## Electric Step Improvements

This reference applies to the following Kwikiee® Electric Series Steps: 22, 23, 24, 25, 26, 28, 30, 31, 32, 33, 34, 35, 36, 37, 38, 39, 40, 42 and 44. Part Number 909770000 (Kwikiee®) or [379145](#) (LCI®) Linkage A; applies to the following Series Steps: 22, 23, 30, 32, 33, 34, 35, 36, 38 and 40. Part Number 909772000 (Kwikiee®) or [379769](#) (LCI®) Linkage B; applies to the following Series Steps: 28, 31, 37 and 39. Part Number 909774000 (Kwikiee®) or [379801](#) (LCI®) Linkage C; applies to 26 Series Steps.

**Fig. 1**

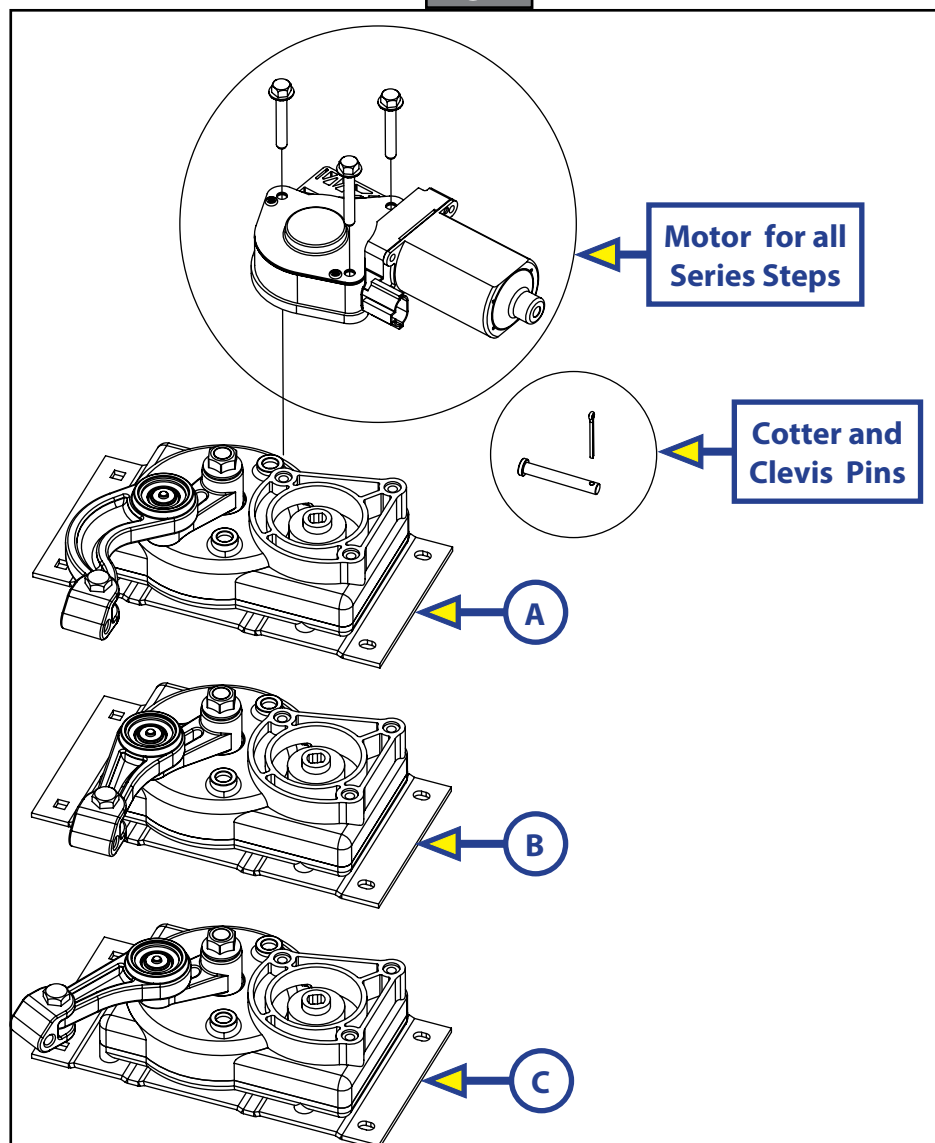
The Replacement Kits contain an IMGL (Integrated Motor/Gearbox/Linkage Assembly), a control unit, a 4-way pigtail, and a fastener kit. Replacing the motor, gearbox, and linkage with the IMGL on a step **that has any other controller than a 909510000 (Kwikie®) or 379146 (LCI®) Control Unit** (as included), requires the installation of the new control unit Part Number 909510000 (Kwikie®) or Part Number 379146 (LCI®) included in the replacement kit. The step improvements were made to increase performance, reliability and the longevity of step operation. The changes also simplify the parts procedure.

### Improved Linkage and Gearbox

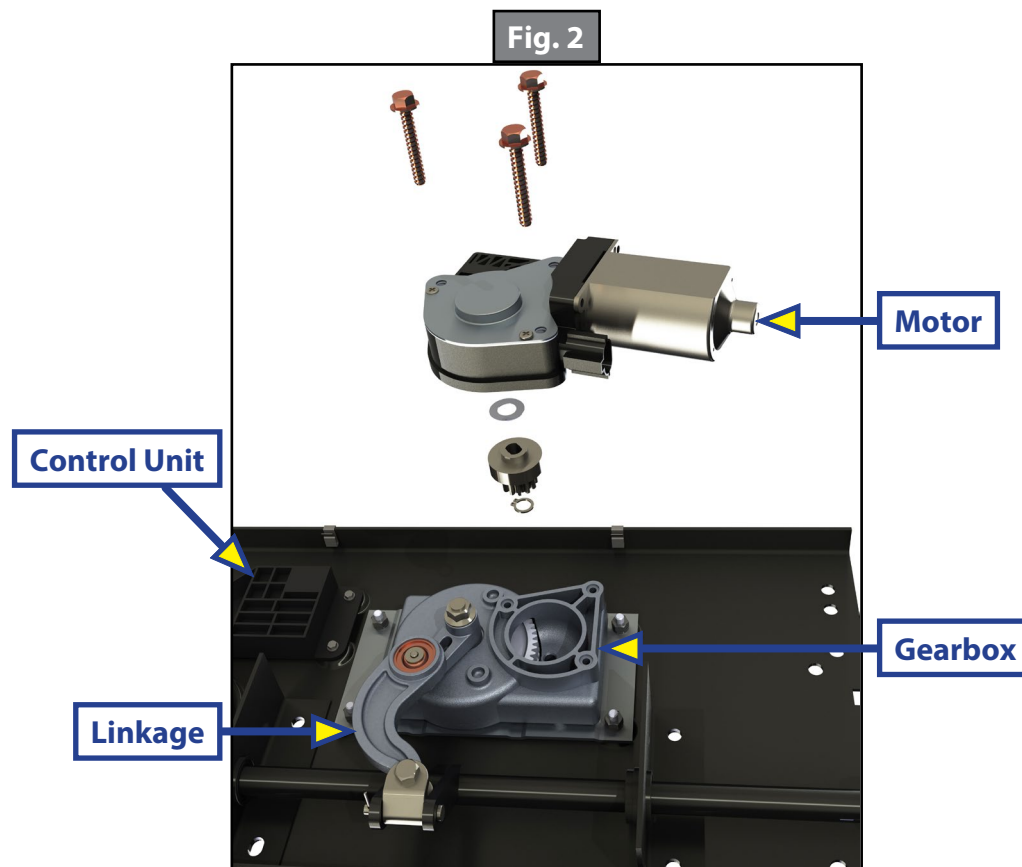
An investment cast, zinc plated steel linkage assembly, is stronger and more resistant to corrosion. There is now a brass spherical outer cage, with a hardened ball linkage, which is stronger and has increased longevity. This change also allows for greater resistance in the tendency for the linkage to oblong. An improved gearbox has also been fully sealed, with a dual ball bearing for greater efficiency and no maintenance. Gearbox case halves are now sealed for consistent alignment and greater weather resistance.
